SERVICE BULLETIN

No. 739

Piper Aircraft Corporation

Restriction of Flap Travel and Inspection
of Wing Flap Flexible Drive Shaft

SKETCH A

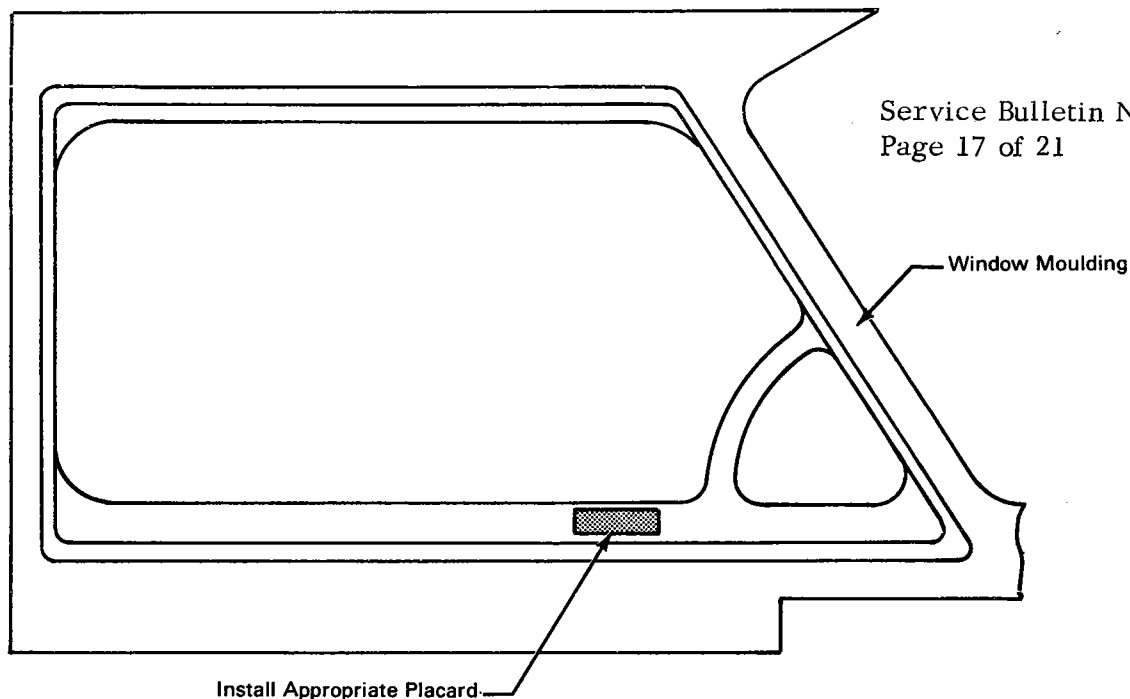
3. Paint a red full flap radial position mark to correspond with the needle position at 25° on the flap position indicator lens. Also, extend a white slippage mark from the indicator case to the lens. (Ref. Sketch A.)
4. Attach the appropriate Flap Operation Placard on the left window molding in plain view of the pilot. (Ref. Sketch B.)
5. For PA-31P aircraft attach appropriate Stall Speed Placard(s) adjacent to the airspeed indicator(s). (Ref. Sketch C.)
6. Make the necessary handwritten changes in pen and ink to the appropriate Airplane Flight Manual/Pilot's Operating Manual/Pilot's Operating Handbook as follows:
 - (a) For Piper Model PA-31-300:
 - (i) Approved Airplane Flight Manual per PAC Report No. 1470 for Model PA-31-300, Serial Nos. 31-2 through 31-511.

FIGURE 2

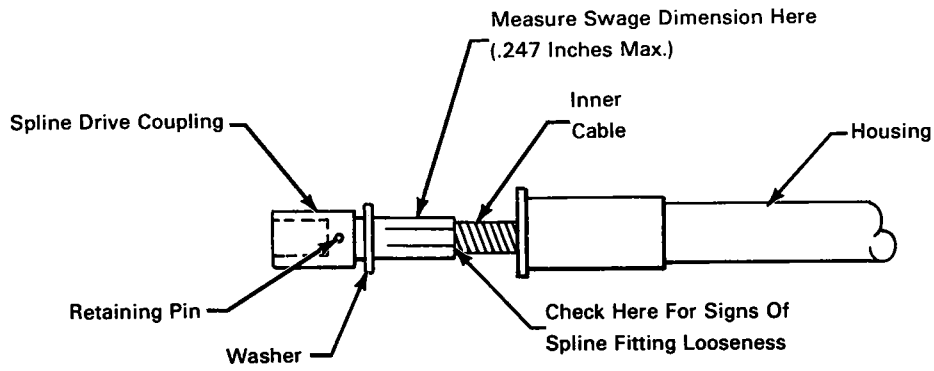
4. Visually inspect the flexible shaft splined drive coupling and retaining pin for evidence of looseness on the cable swage fitting. (Ref Sketch D, Figure 2.) If any looseness is apparent, replace the flexible shaft assembly.

5. Inspect the swaged fittings at both ends of the flexible shaft as follows:
 - a. Expose the swaged portion of the inner cable at the motor end by twisting the outer housing two (2) turns clockwise. The swaged portion of the cable should have eight (8) flats clearly visible and free from deep scratches or wear marks. (Ref Sketch D, Figure 2.)

5. Inspect the swaged fittings at both ends of the flexible shaft as follows:
 - a. Expose the swaged portion of the inner cable at the motor end by twisting the outer housing two (2) turns clockwise. The swaged portion of the cable should have six (6) or eight (8) flats clearly visible and free from deep scratches or wear marks. (Ref. Sketch D, Figure 2.).

- b. Using a micrometer, or dial caliper, measure the diameter of the swage for each of the flats at the middle of the swaged portion of the cable. A total of three (3) measurements should be taken for the six (6) sided swage and a total of four (4) measurements should be taken for the eight (8) sided swage. If any of the measurements exceed .235 inch for the six (6) sided cable or .247 inch for the eight (8) sided cable, replace the drive shaft.

Measure Swage Dimension Here
(.235 Inches Max. for Six (6) Flats)
(.247 Inches Max. for Eight (8) Flats)

FIGURE 4

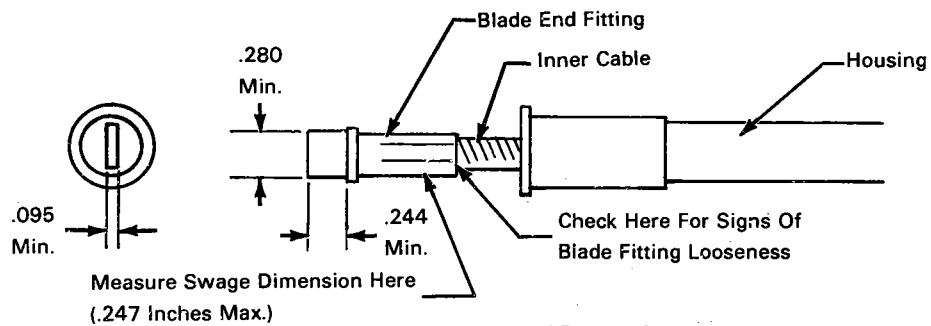
- d. Inspect the drive blade dimension as shown in Sketch E, Figure 4.

SKETCH E

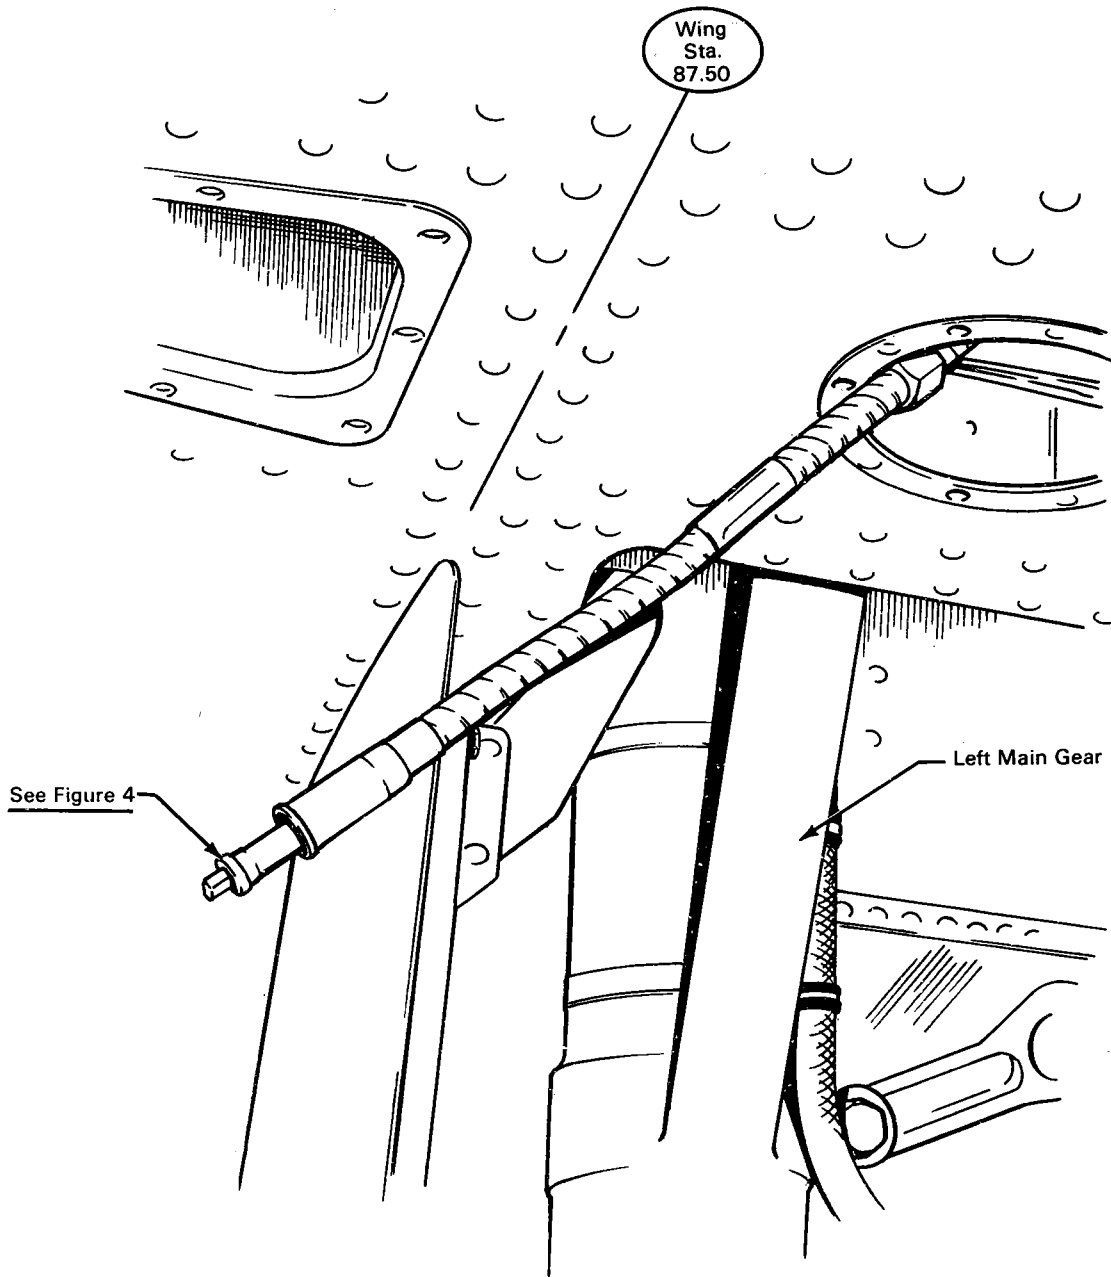
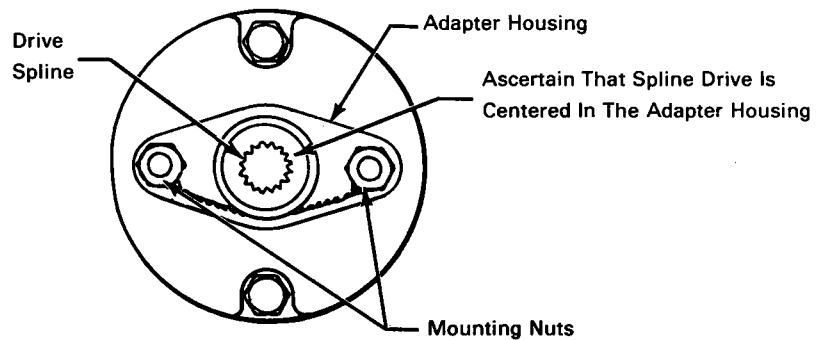
- c. Disconnect drive shaft from the flap transmission. Using caution not to damage the shaft housing, route inboard through the Sta. 87.50 bulkhead. (ref Sketch E.) Inspect the swaged portion of the drive blade fitting end as described in "a" and "b" above.

7. While holding the transmission end of the drive shaft stationary, twist the motor end one (1) turn clockwise and release. Inspect for evidence of movement between the inner cable and the swaged fittings at both ends. Turn cable one (1) turn counter-clockwise and repeat inspection. (Ref Sketch D, E.) If movement or separation between the inner cable and the swage fitting is apparent, replace the flexible shaft assembly.

**FIGURE 6****FIGURE 5****SKETCH F**

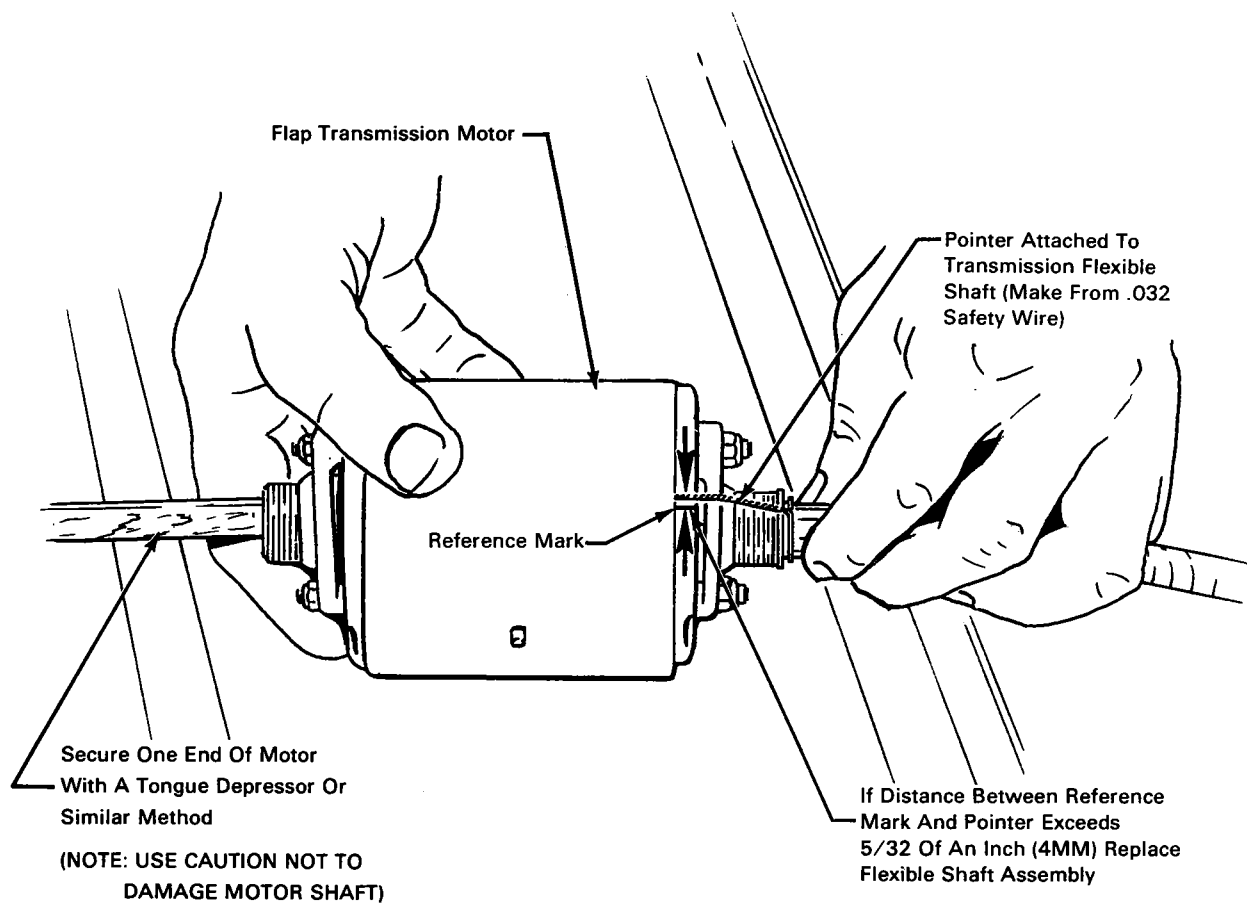
- a. Twist a piece of .032 safety wire around the swaged fitting at the motor end of the drive shaft to form a pointer (Ref Sketch F, Figure 5). With one end of the flap motor armature shaft secured engage the opposite end into the flexible shaft spline.

- b. Hold the spline end of the flexible shaft securely with one hand, and gently turn the flap motor to remove rotational play in the splines. Place a reference mark on the motor housing adjacent to the wire pointer (Ref Sketch F, Figure 5). Turn the flap motor gently in the opposite direction to remove rotational play and place another reference mark on the motor housing. If any distance between these two marks exceed 5/32 of an inch (4 mm) replace the flexible shaft assembly (Ref Sketch F, Figure 5).

8. Determine that the inner cable moves freely within the housing, and may be turned easily by hand. If there is any snagging or binding the cable must be replaced.
9. Reassembly of the flap system:
 - a. Ascertain that the flap motor shaft is centered within the motor adapter housing (Ref Sketch F, Figure 6.).
 - b. Lubricate both ends of the flexible shafts with MIL-G-23827 grease.
 - c. Reassemble and verify flap system rigging as outlined in the Surface Controls section (Chapter 5) of the appropriate Service Manual.
10. Reinstall floorboards and access panels.
11. Log compliance with Piper Service Bulletin No. 739, PART II, in the Aircraft Logbook.
